Figure 76–10—ONU Idle Deletion state diagram

Figure 76–10—ONU Idle Deletion state diagram

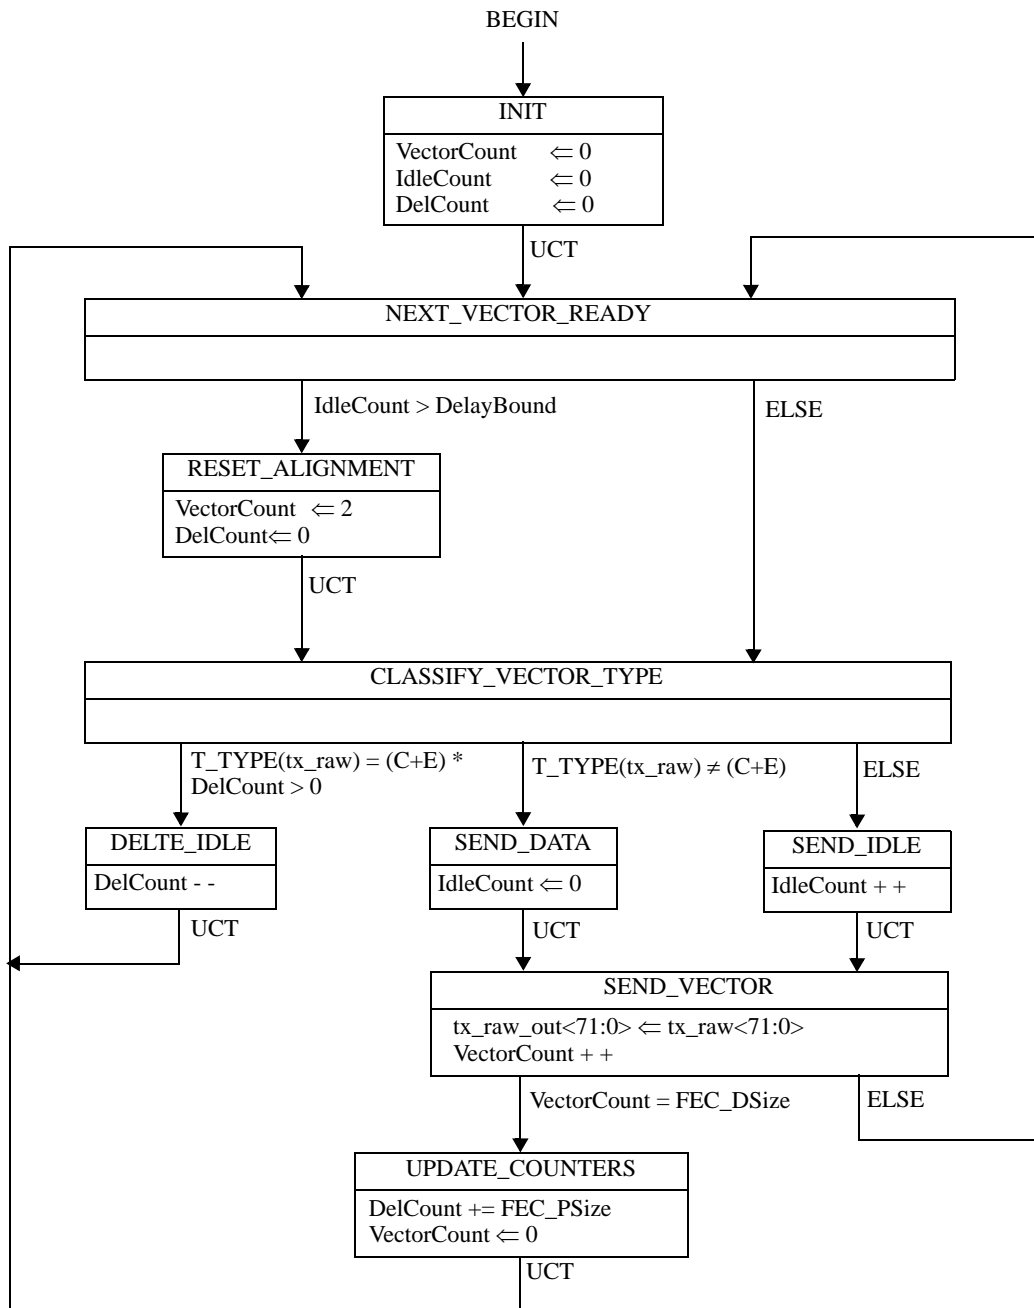
Remove definitions of the following variables:

HalfShift, tx_next<35:0>, tx_temp<35:0>

Remove definitions of the following functions:

C_TYPE (wherever it is defined)
